"MOVABLE LOADING BRIDGE HAVING
AN INFLATABLE FLEXIBLE BODY"

REVISED RESPONSE TO OFFICE ACTION

LETTER SUBMITTING PROPOSED DRAWING CHANGES

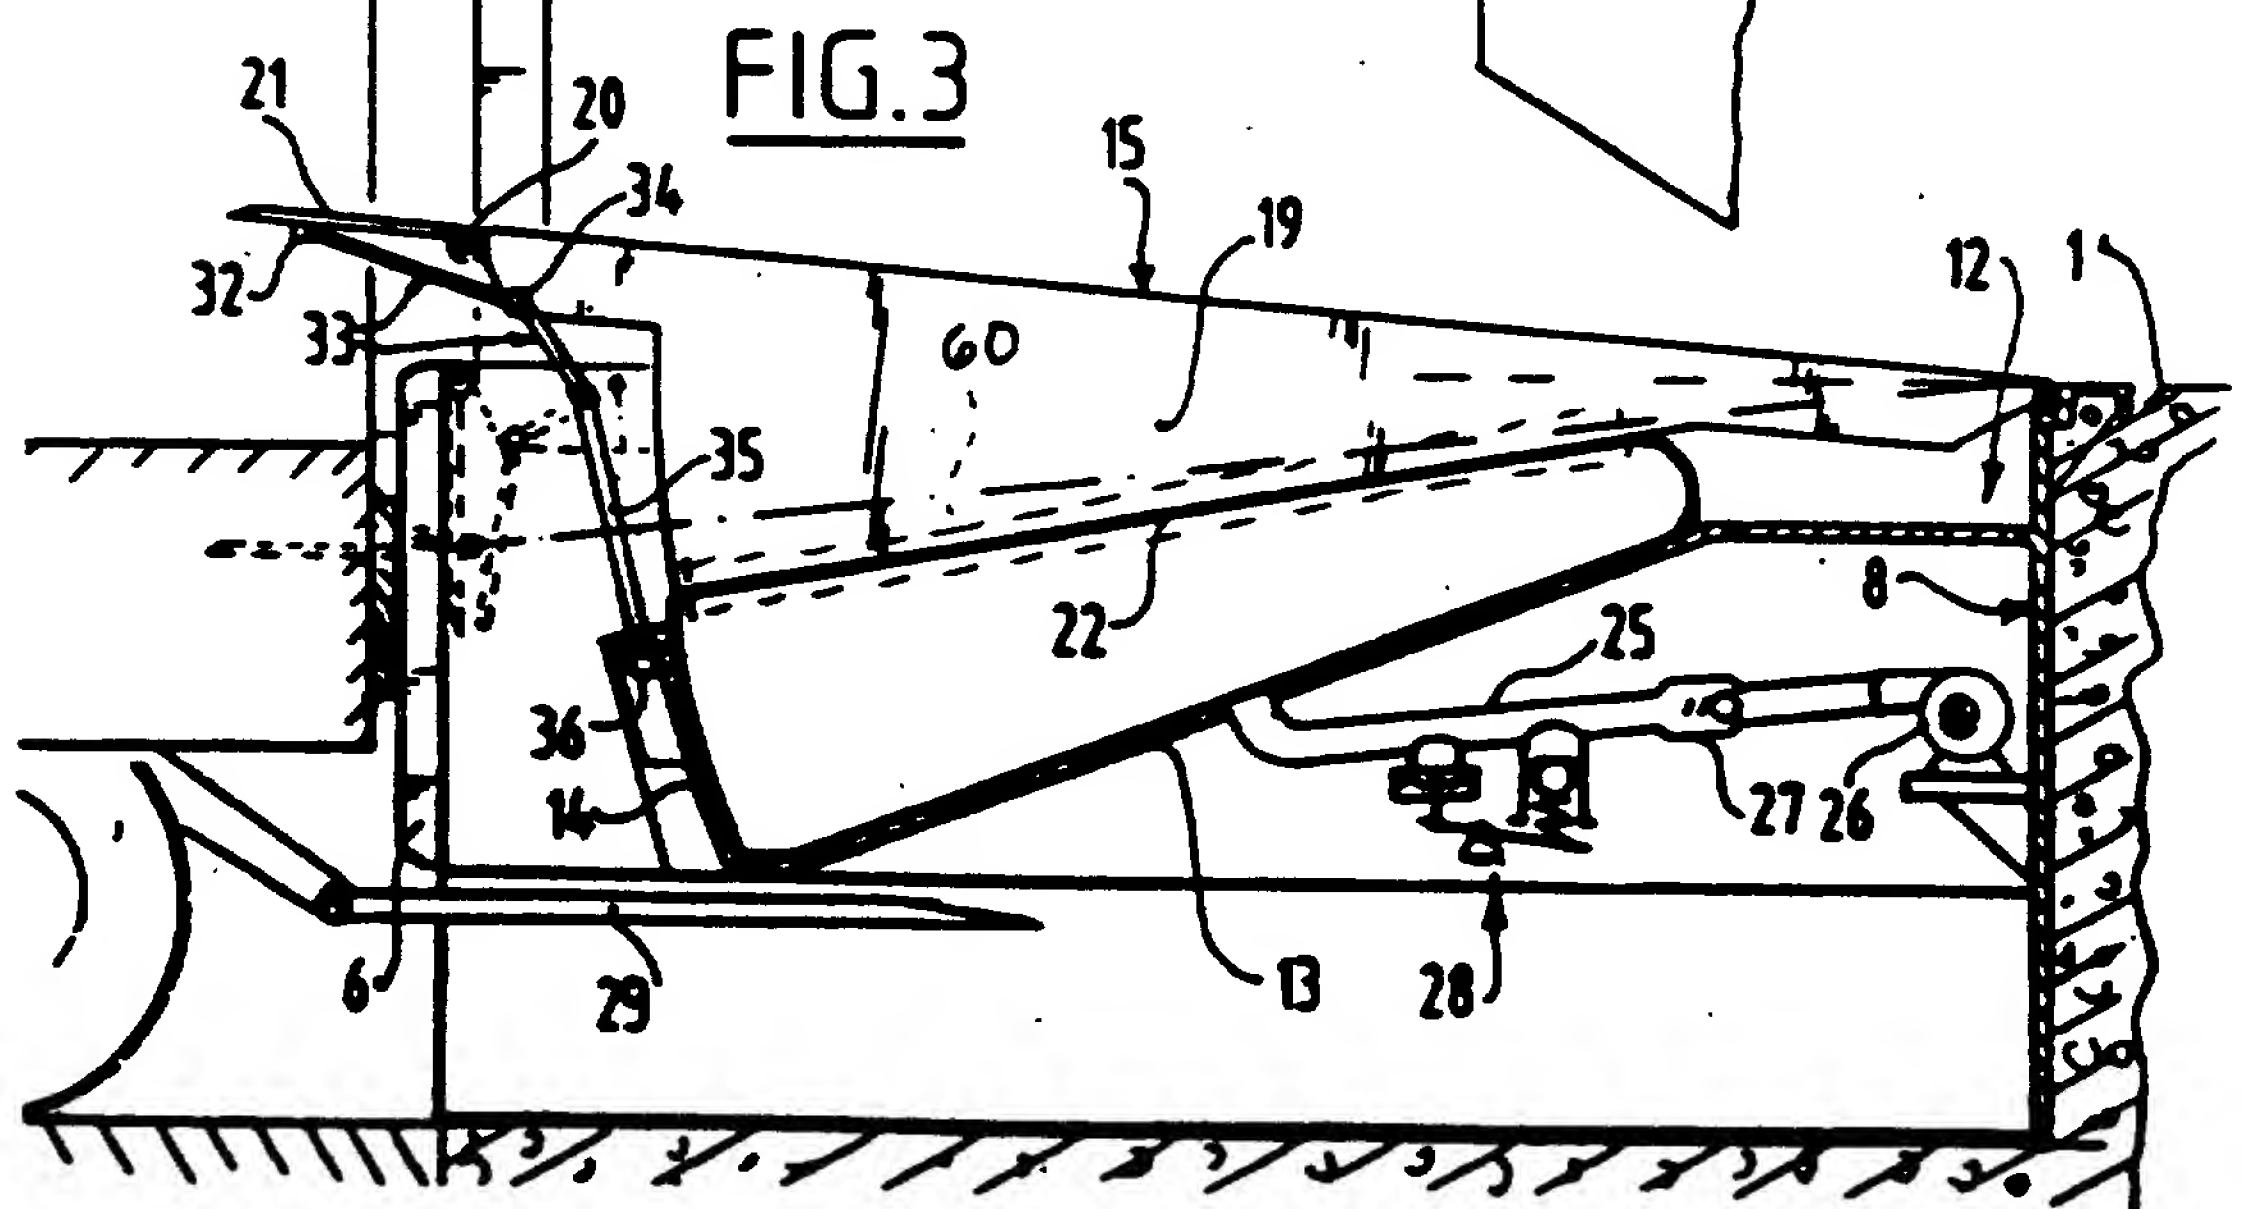
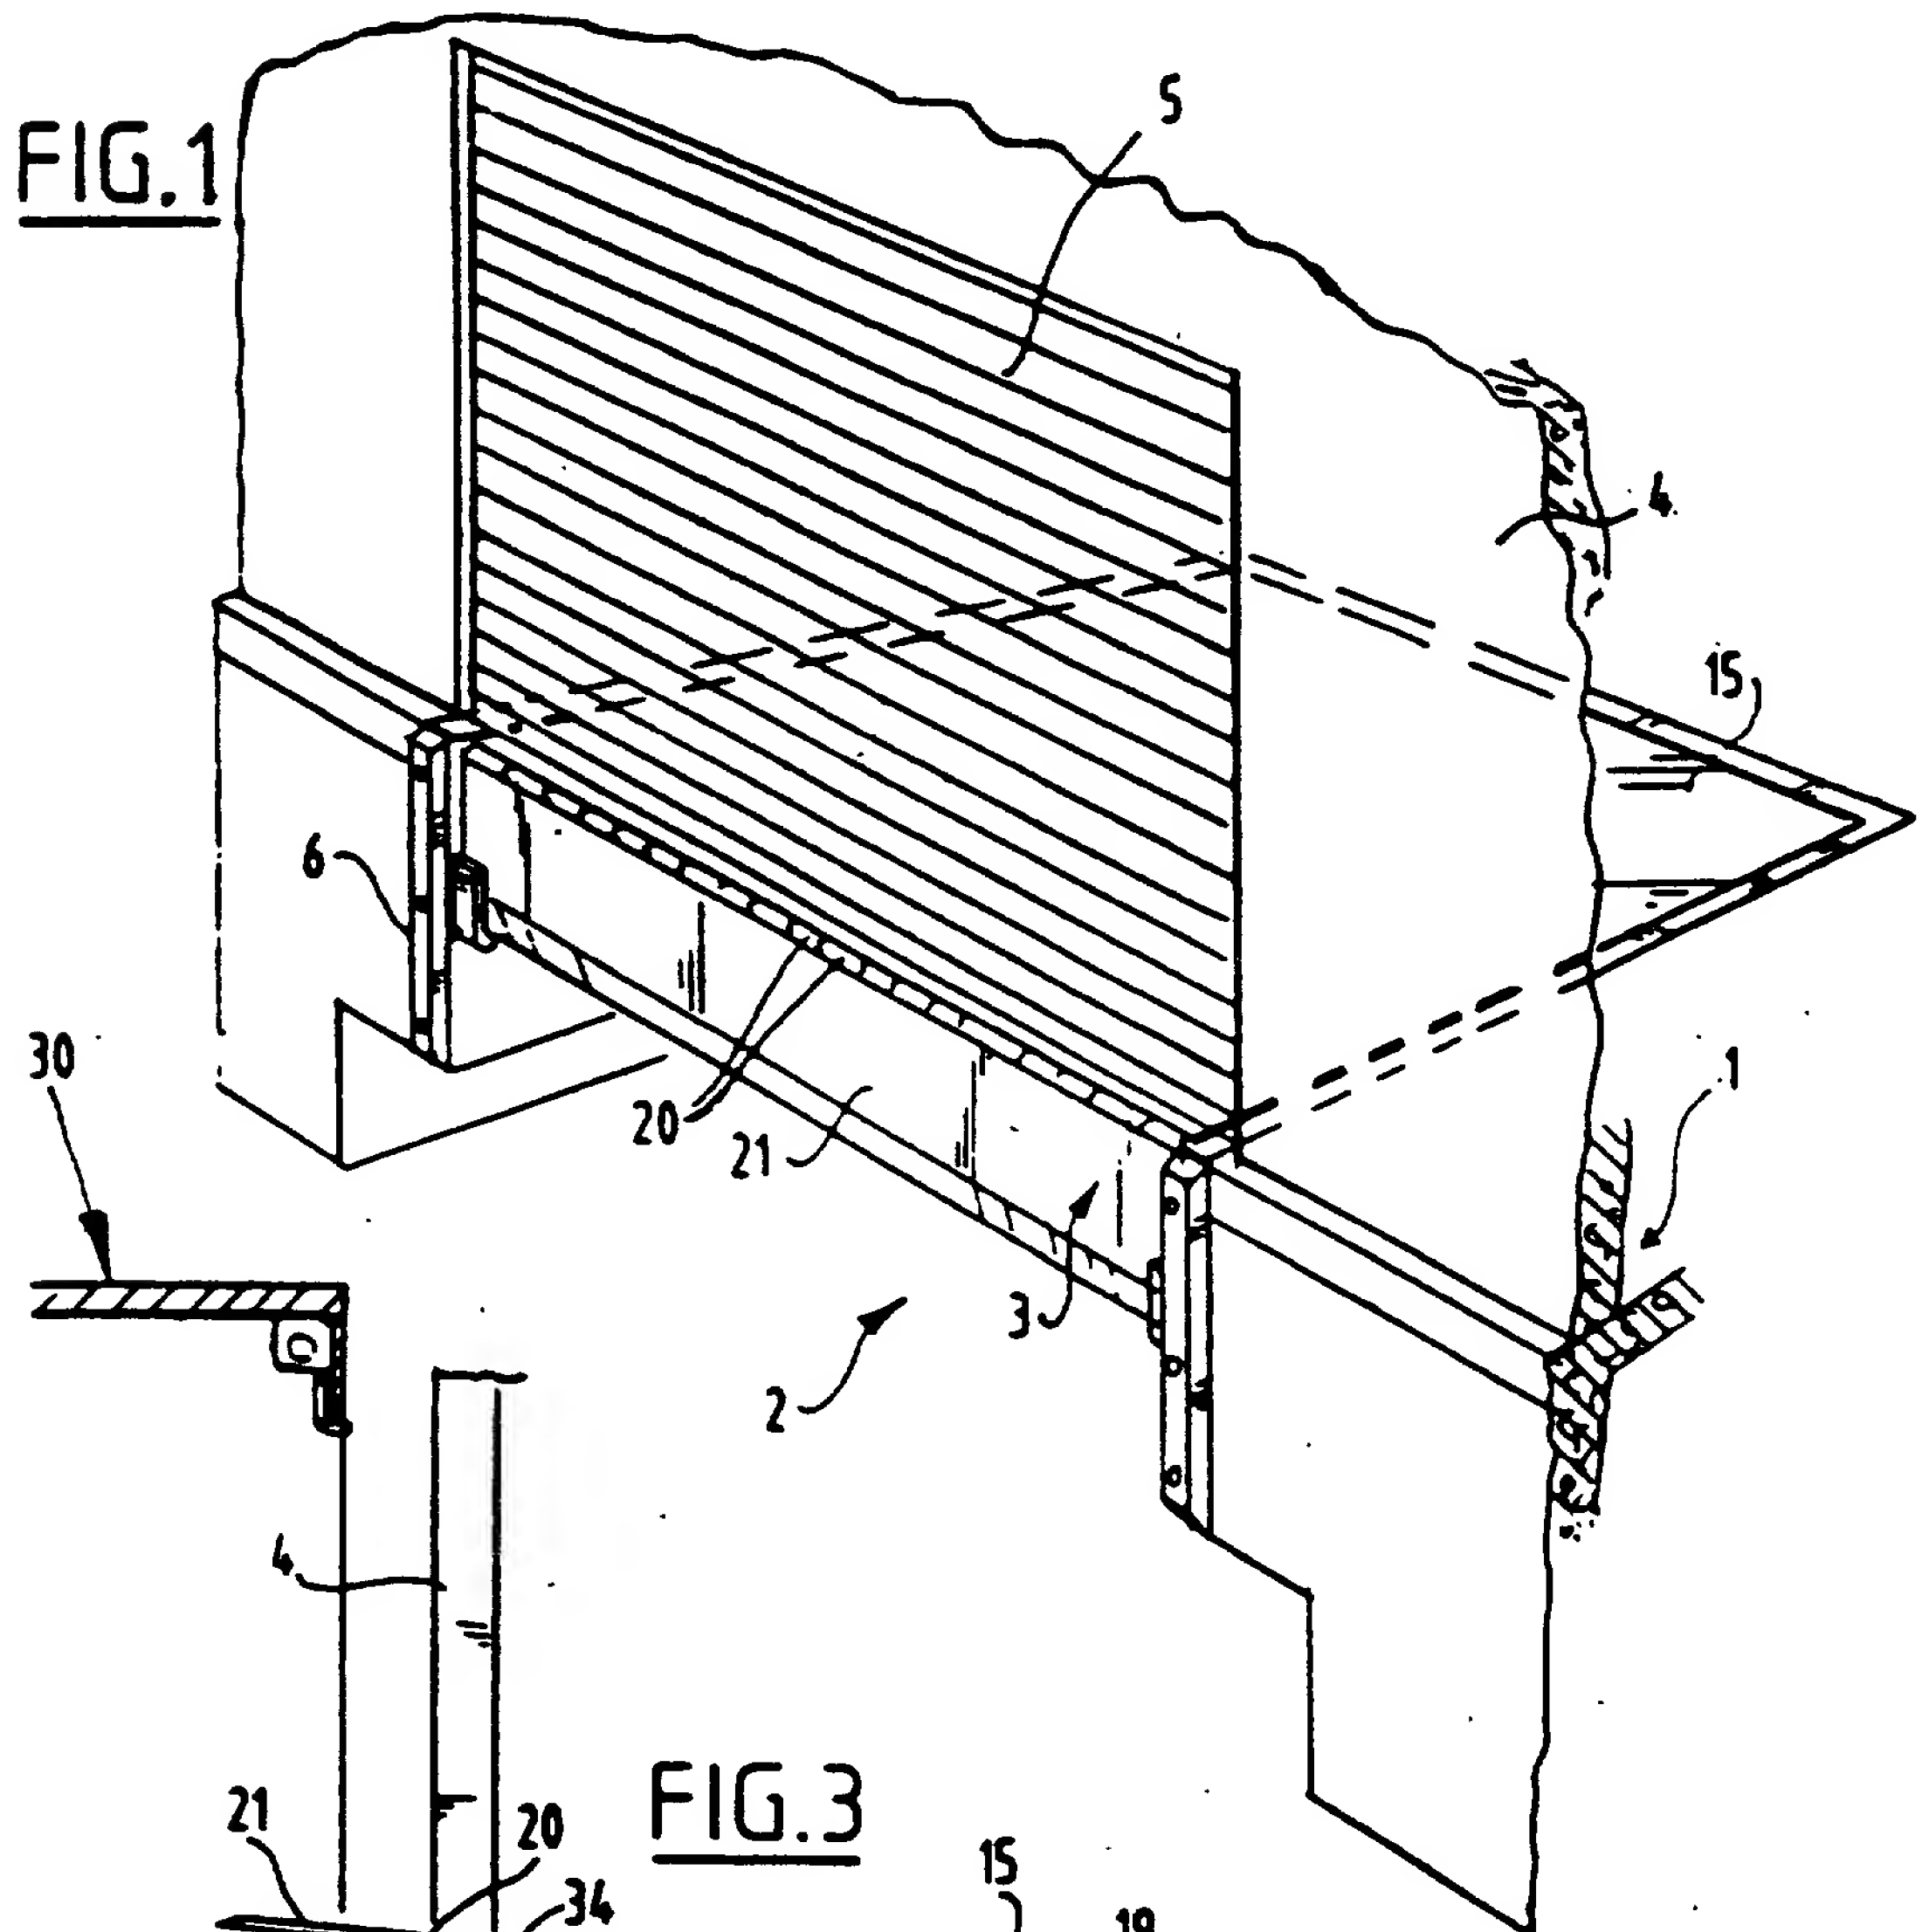
The drawings are objected to under 37 CFR §1.83(a) on the grounds that they do not show the claimed buttons of claim 21. To correct the problem, Applicant submits herewith a copy of a Letter Submitting Proposed Drawing Changes, which seeks to amend Figs. 2 and 3 to schematically illustrate the flexible body "buttoned" to the planar member, as shown in red ink on the enclosed drawings (The original Letter Submitting Proposed Drawing Changes was filed with Applicant's Response filed June 18, 1996). Further, Applicant has amended the specification to include a reference numeral for the buttons. No new matter has been added. The proposed changes to the drawings merely add subject matter already described in the Specification at column 2 lines 57-59. Entry of this amendment to the drawings and withdrawal of the objection are respectfully requested.

Applicant proposes amendment of Fig. 3 of the drawings as indicated in red ink on the attached sheet.

The changes to the drawings are in response to the Examiner's objection to the drawings set forth in the Office Action dated March 5, 1996. These changes add a schematic representation of the buttons described in the specification at column 2, lines 57-59, along with a corresponding reference numeral "60".
